DOCKETS 50-266 AND 50-301  
ASME SECTION XI PRESSURE TEST PROGRAM  
REQUESTS FOR RELIEF  
POINT BEACH NUCLEAR PLANT UNITS 1 AND 2

## RELIEF REQUEST PTP-3-04

COMPONENTS: ASME Class 2 EB-9 Main Feedwater Piping (Units 1&2), associated with Point Beach Modifications 89-072 (Unit 1) and 89-073 (Unit 2).

DRAWINGS: M-202 Sh 2 (Unit 1)  
M-2202 Sh 2 (Unit 2)

FIGURE 1

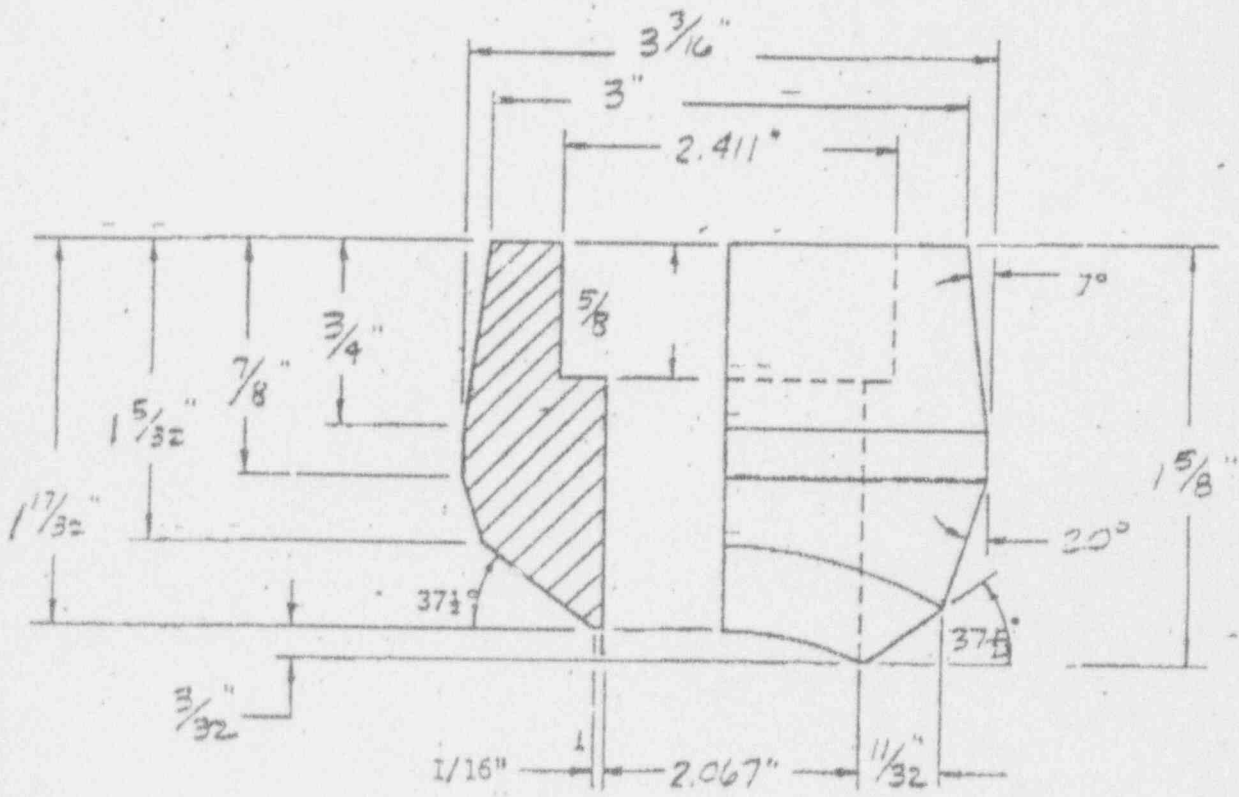
- (c) In addition to the pressure test specified in (a) above, a surface examination of the final weld pass shall be performed on all socket welds which are part of the modification. Surface examinations of the root weld pass and final weld pass shall be performed on all full penetration welds joining socket-weld pipets (see figure 1) to the 16 inch ASME Class 2 EB-9 main feedwater piping.
